Glenwood MS Envelope Renovation
Addendum Number 1
3/13/2020

To: All Plan Holders
Project: HCPSS Glenwood MS Envelope Renovation
Re: Addendum Number 1

To the Contract Drawings and Specifications for the referenced project as dated below, as prepared by Hord Coplan Macht Architects in conjunction with OAK Contracting LLC, this addendum includes changes and clarifications to the Contract Documents as follows:

Glenwood MS Envelope Renovation
HCM Project No. 219169.00

3K|WINDOW TYPE "E"

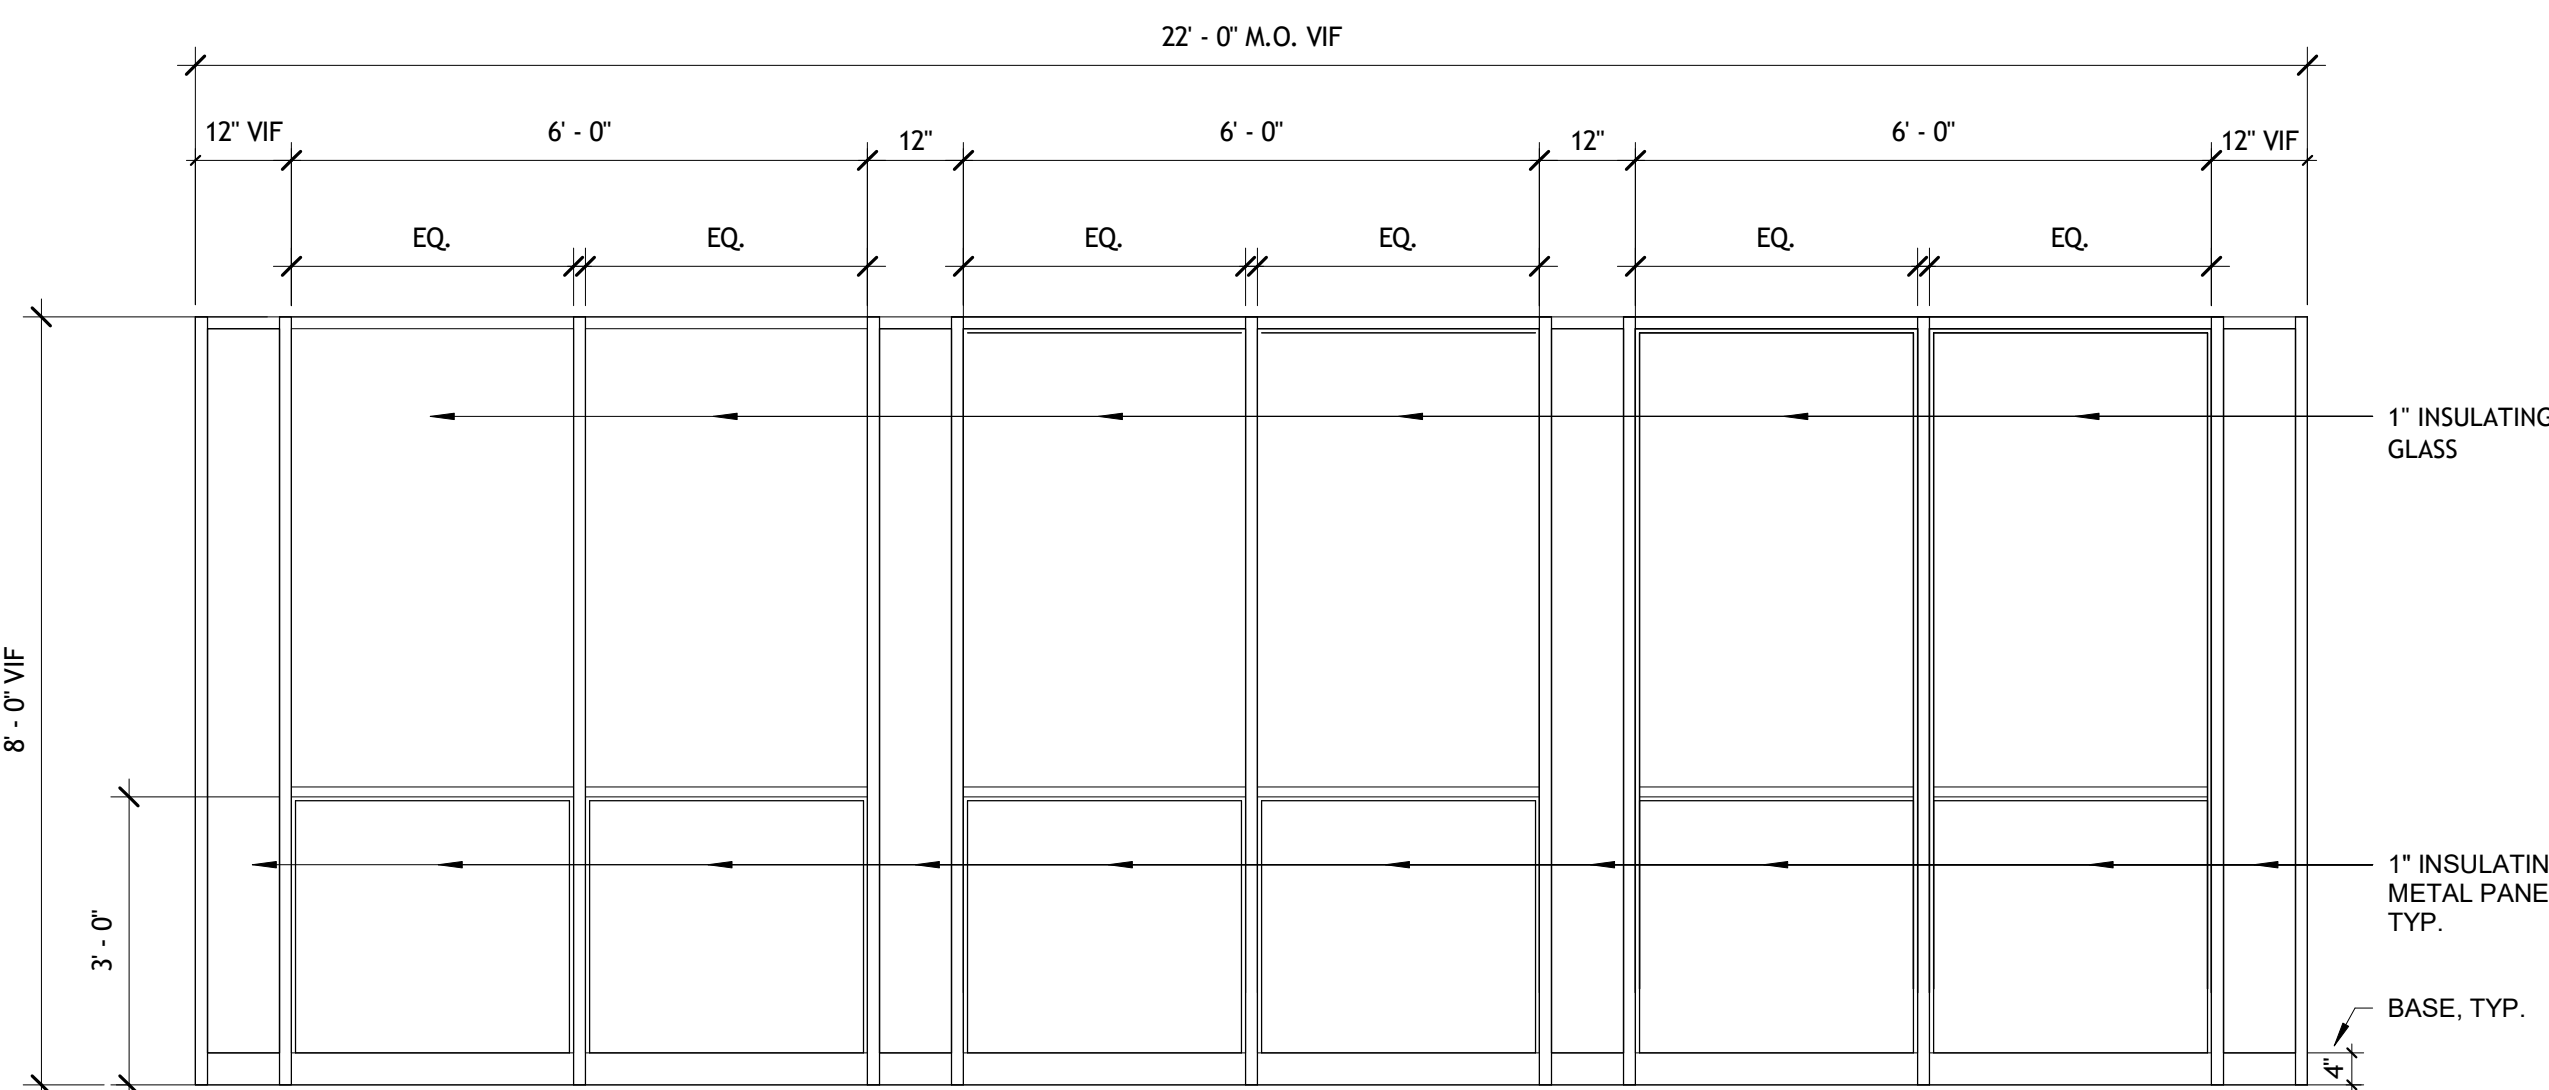
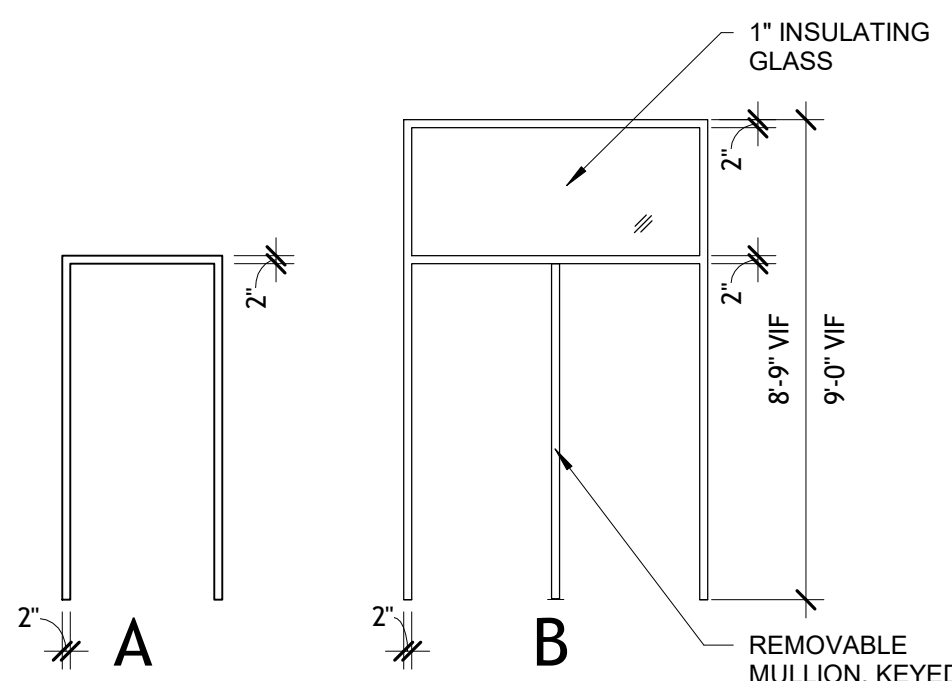
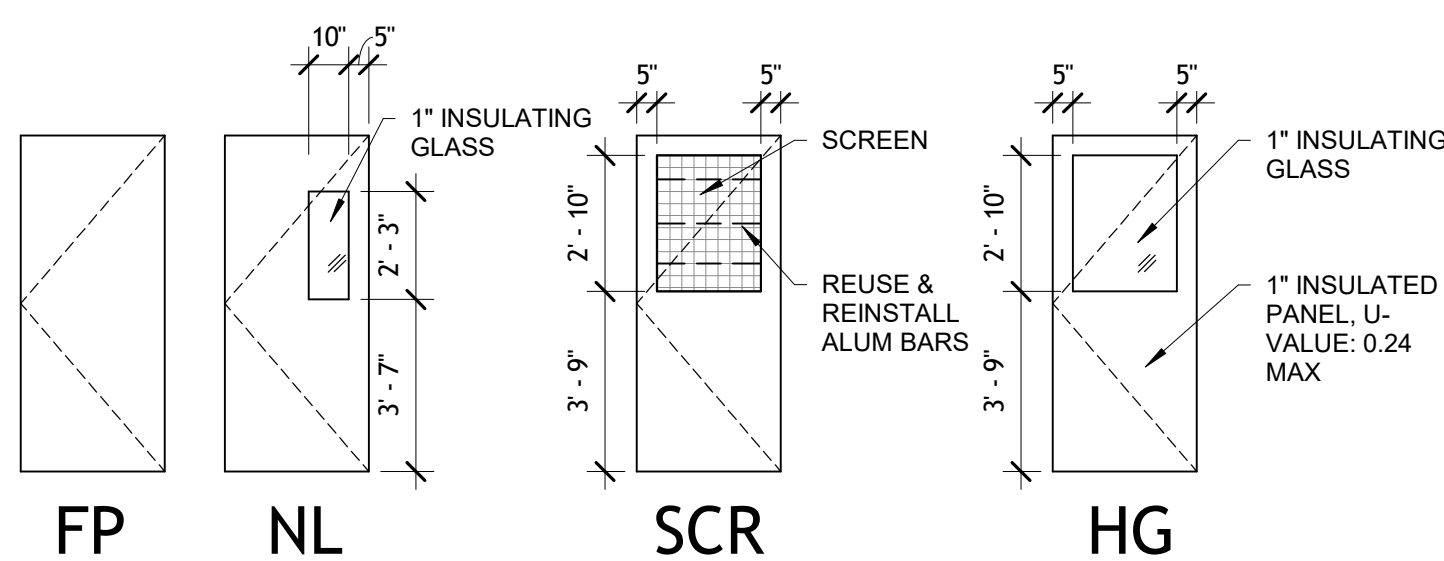
The door schedule on drawing A9.01 notes that Door 106 will be a HM door with an AL frame. Please confirm if this is accurate.

On drawing A9.01, the door schedule indicates HG type doors but the drawings show 2 lite full vision doors. Please clarify if the bottom lite is filled by metal panels.

On drawing A9.01, door NL shows a small 10"X27" vision lite in it, please confirm if this is correct.

Please clarify the type of lights that are to be provided for the storefront doors detailed on drawing A9.01.

On drawing A9.01/detail 8A, will the storefront be stick built or screw spline fabrication?

On drawing A9.01/detail 8A, what is the overall width of storefront frame N

Can you provide a hardware list for the door listed on the door schedule on sheet A9.01? There are no hardware sets listed in the spec.

That is correct, + or -. Use the industry standard for a single insulated glass lite door.
